Addendum

Planning Committee

Planning Committee - Wednesday, 1 November 2023, 7.30 pm

ADDENDUM

Drawing Title
SITE WIDE
VERTICAL PRIVACY BLADE DETAIL
HATCH GARDEN

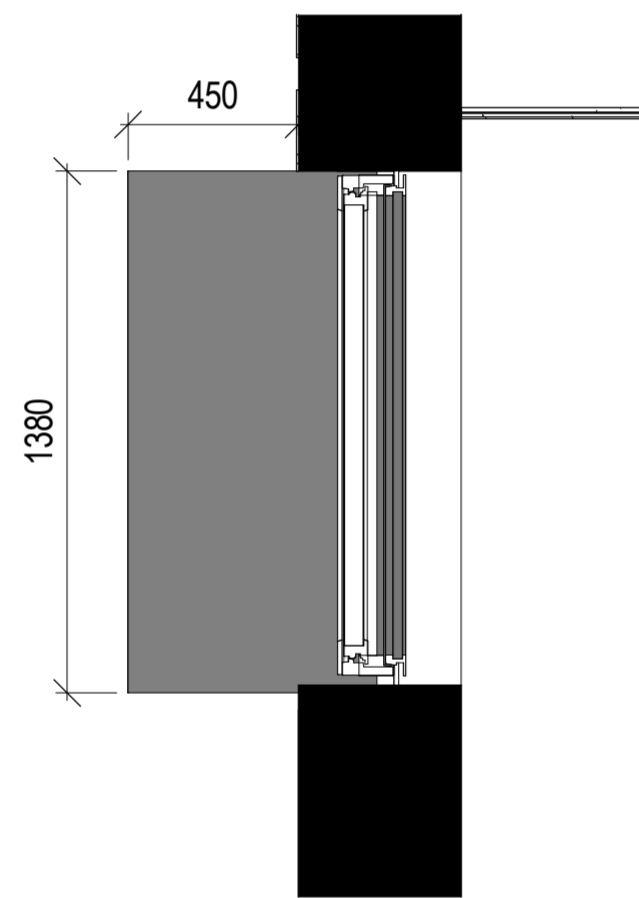
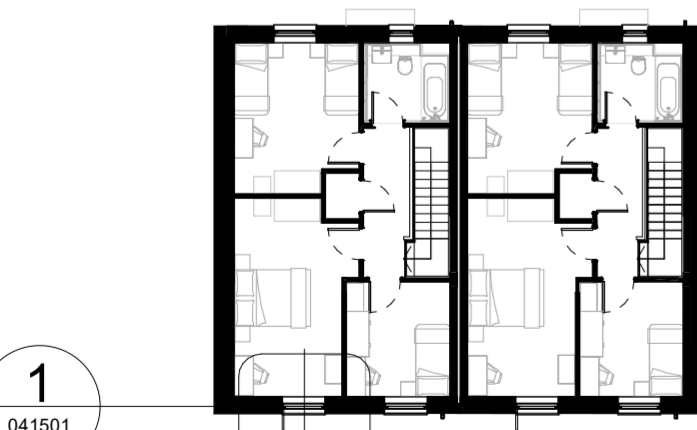
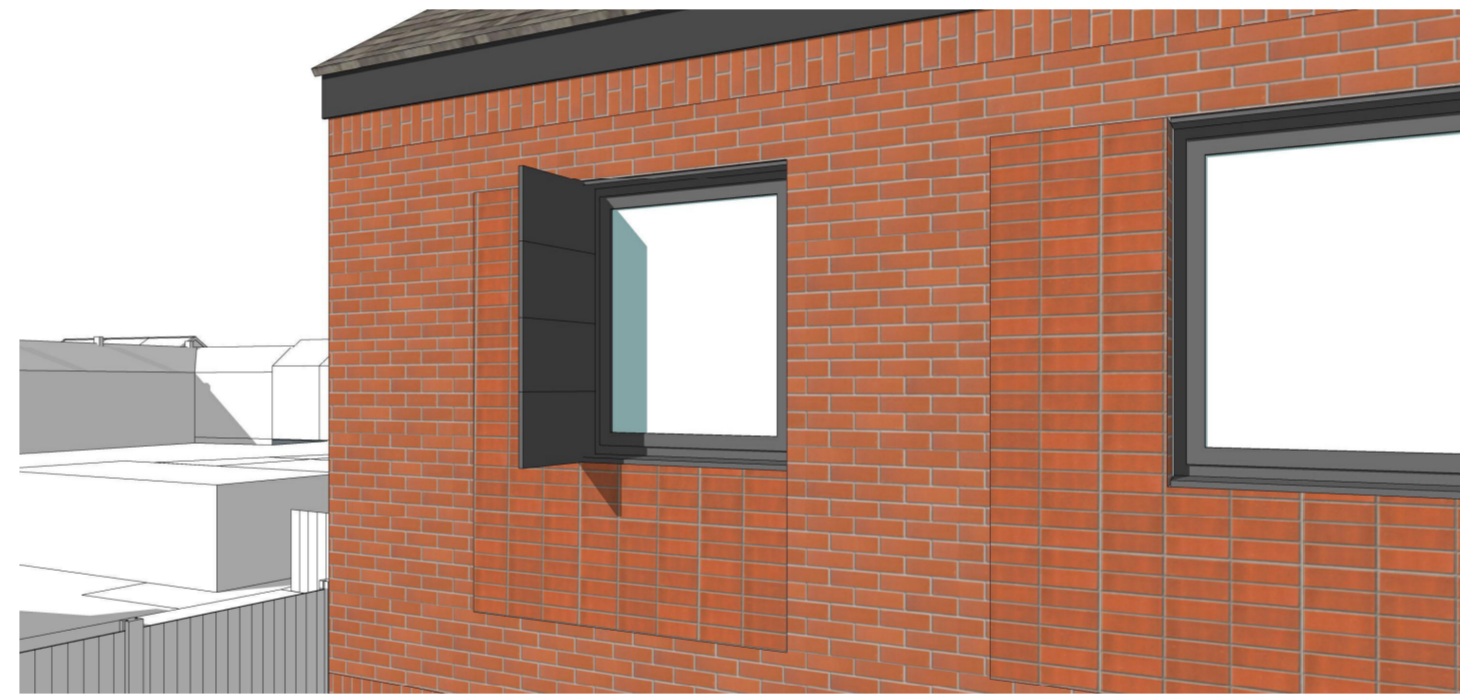
Vertical privacy blade information

The plans showing the privacy blade information were not included within the agenda pack. For ease of reference a copy of the plan is attached at **Appendix A** of this addendum

Appendix B

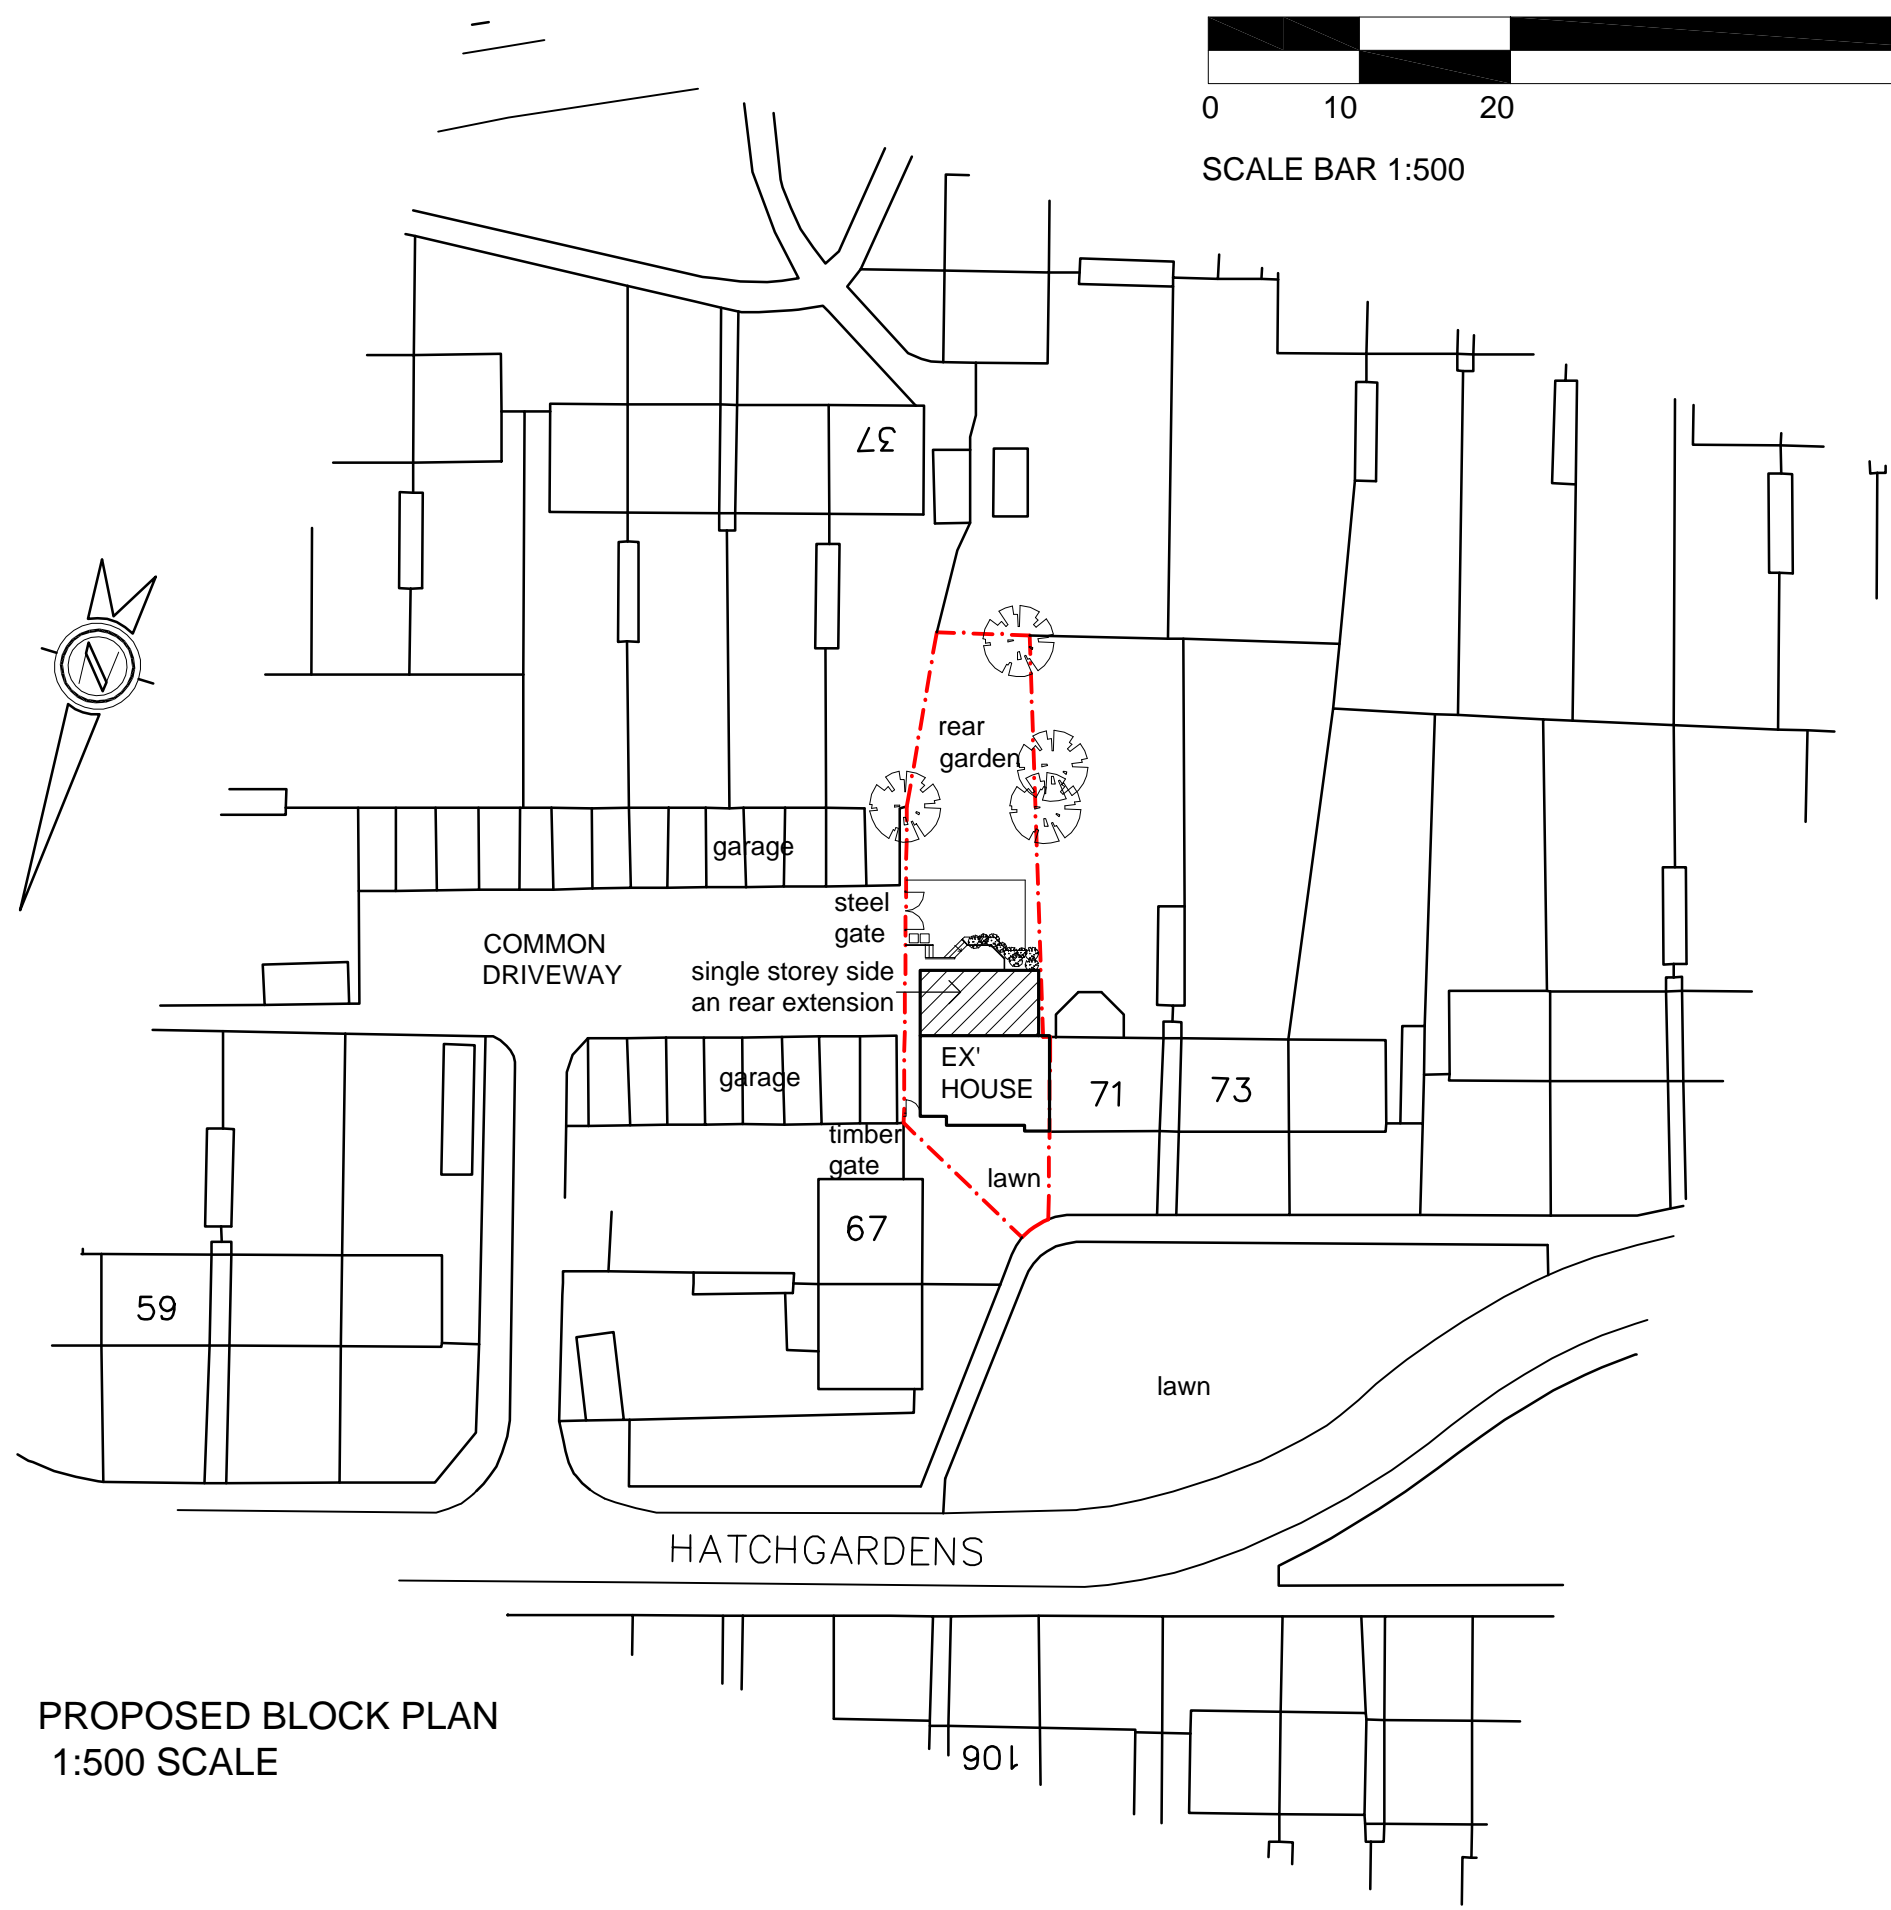
Potential boundary discrepancies

It was noted on the Planning Committee Site Visit that the boundary between the site and the property to the west, 69 Hatch Gardens, does not match that shown on the submitted location plan. A photograph showing the discrepancy is shown at **Appendix B**.

On review of the 2013 permission referred to in the committee report and the most recent 2018 permission (18/01749/HHOLD) it is evident that the red line for the current application is correct and that the applicant does not own the strip to the west of the northern garages (the red line plan for the 2018 permission and proposed plans are attached at **Appendix C**). It appears that the neighbour did not replace the boundary when they completed the extensions approved under the 2013 and 2018 permissions and therefore they appear to be using part of the Raven application site as bin storage.

“I can confirm that the red line boundary has been drawn correctly on the plans and is accurate according to the title plans.

As you’ve identified, it is the neighbour who has incorrectly built the wall which has extended into Raven’s land.”

Therefore officers are satisfied that the red line plan for the current application is correct. Any issues regarding land ownership are private matters between the applicant and the neighbour and this matter will need to be resolved prior to commencement of the development. **Appendix C** also includes plans showing what the side windows at no. 69 serve. As per paragraph 6.26 of the committee report these windows are either secondary windows or serve non-habitable rooms, two of which are high level, and therefore there would be no impact on the neighbouring property in this regard.
